Docket Number:	07-AFC-06C
Project Title:	Carlsbad Energy Center - Compliance
TN #:	203300
Document Title:	Project Owner Responses to Data Request Set 3 (Nos. 67-84)
Description:	N/A
Filer:	Dee Hutchinson
Organization:	Locke Lord LLP
Submitter Role:	Applicant Representative
Submission Date:	10/31/2014 3:33:13 PM
Docketed Date:	10/31/2014

Re: Carlsbad Energy Center Project Petition to Amend (07-AFC-06C)
Responses to Data Request Set 3 (Nos. 67–84)

Data Response Set 3 (Response to Data Requests 67 to 84)

FIGURE DR24-3R1
Transmission Line Pole Cross Section
Double-circuit Deadend Configuration
Carlsbad Energy Center Project
Carlsbad, California (07-AFC-06C)

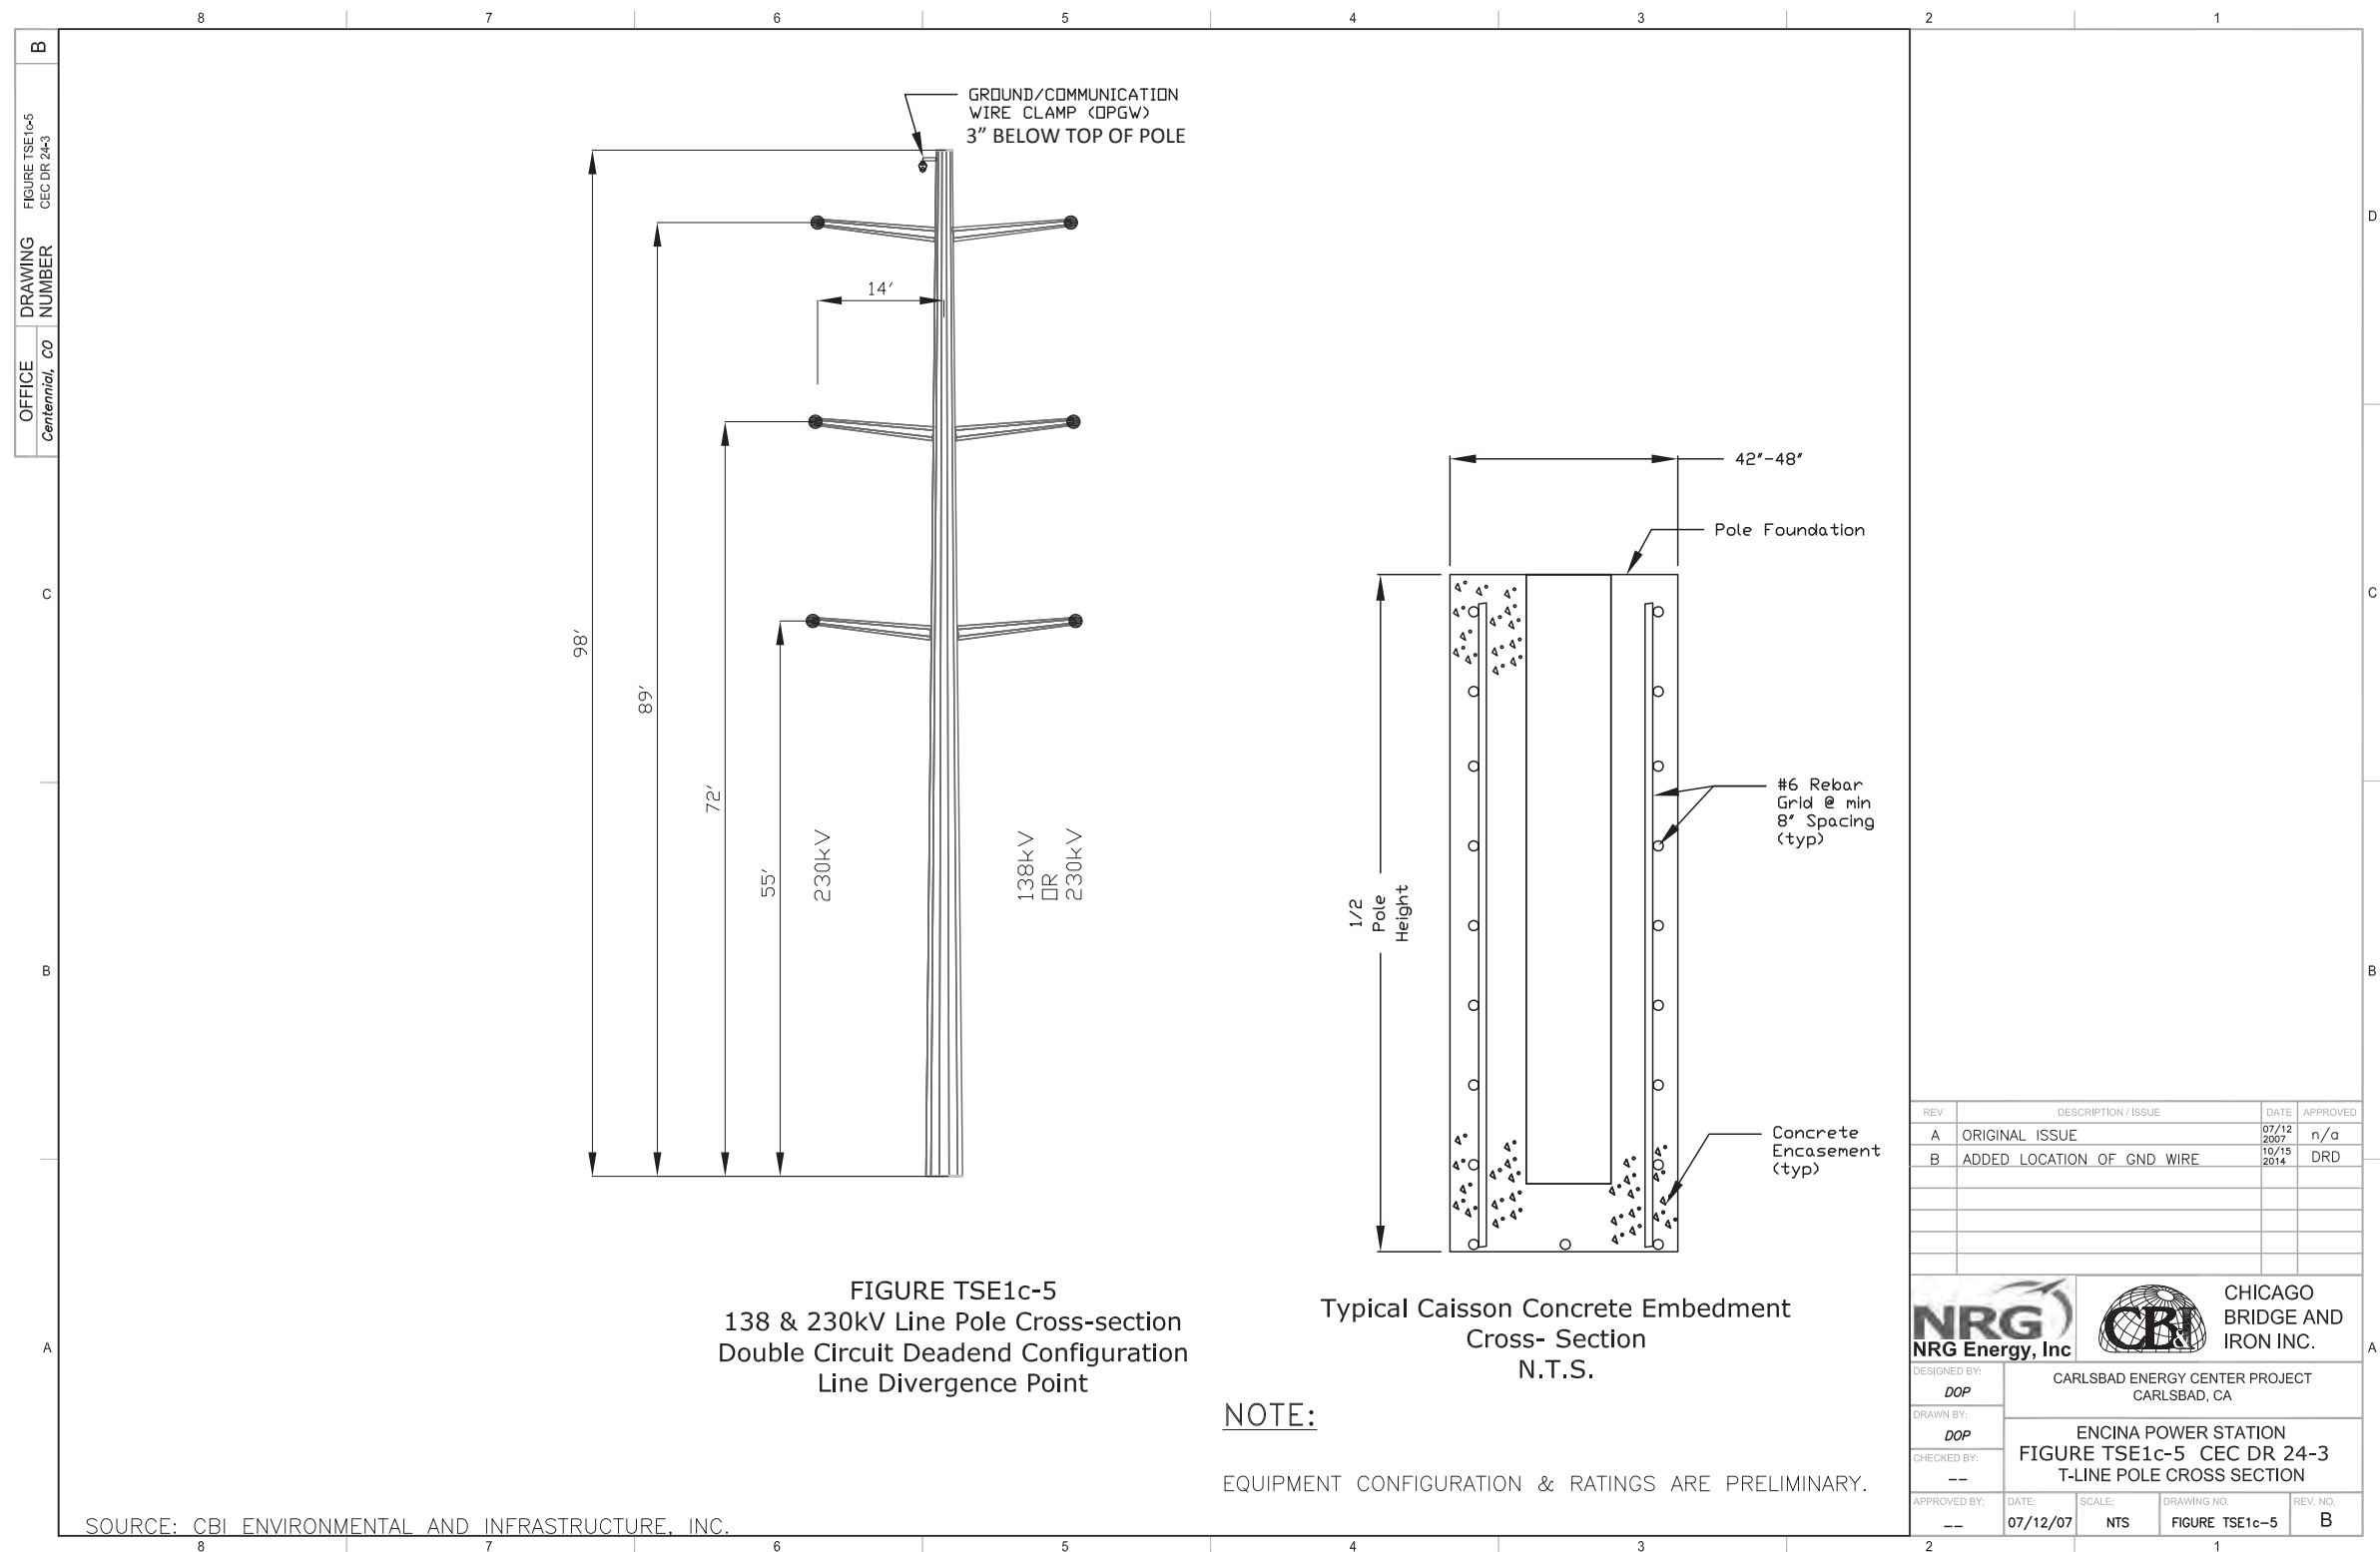
- 75 Resubmit Steel pole Figures 24.1, 24.2 and 24.3 showing the specific locations of the ground wire (size: ½ inch EHS steel), and any required communication cable/wire, include their respective clearances from the ground level.

Figures DR24-1, DR24-2, and DR24-3 have been revised to depict OPGW (Optical Ground Wire) on the pole structures.

FIGURE DR76-1a
NCTD Rail Corridor Cross Section
 Carlsbad Energy Center Project
 Carlsbad, California (07-AFC-06C)
 Petition to Amend

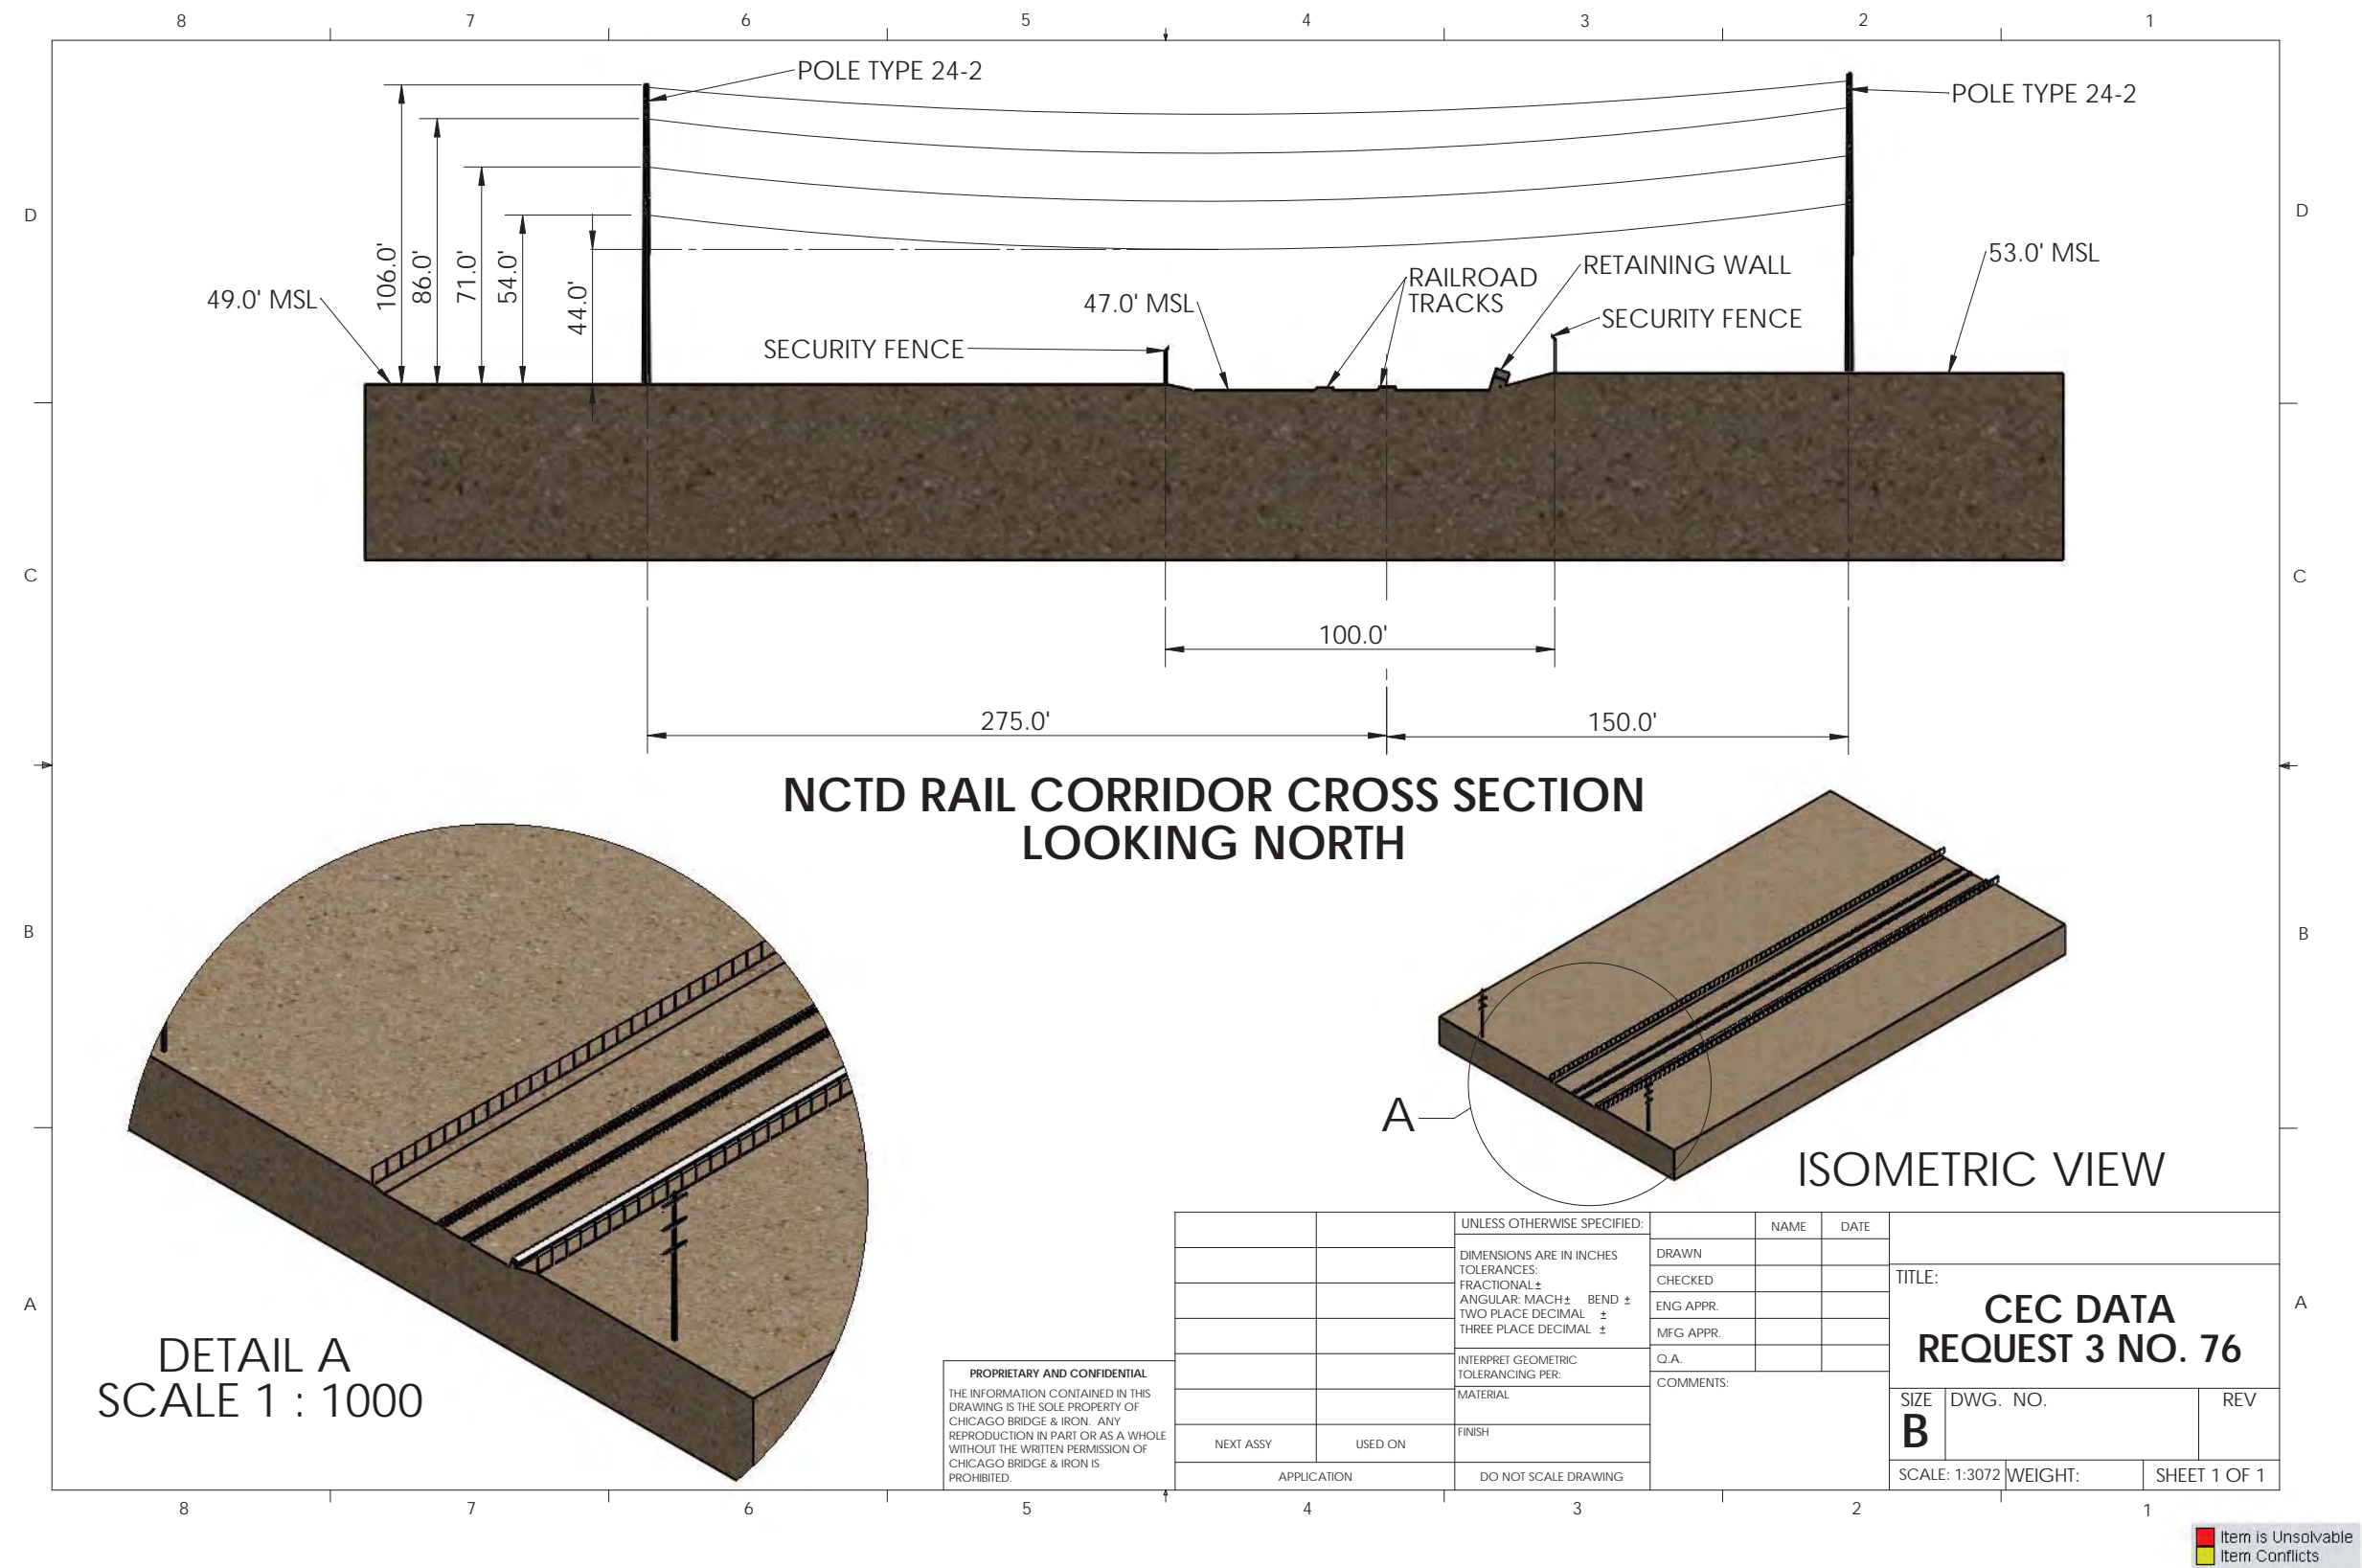
76. For the overhead gen tie lines crossing over the North Coast Transit District Rail Corridor (NCTD) double tracks, please submit overhead line diagrams (plan and side views) showing clearance of the lowest conductor of the line in feet above the railway tracks, as well as positions of the poles (including type of poles) on both sides of the NCTD railway tracks.

Figure DR76-1 demonstrates the crossing over the NCTD railway tracks.
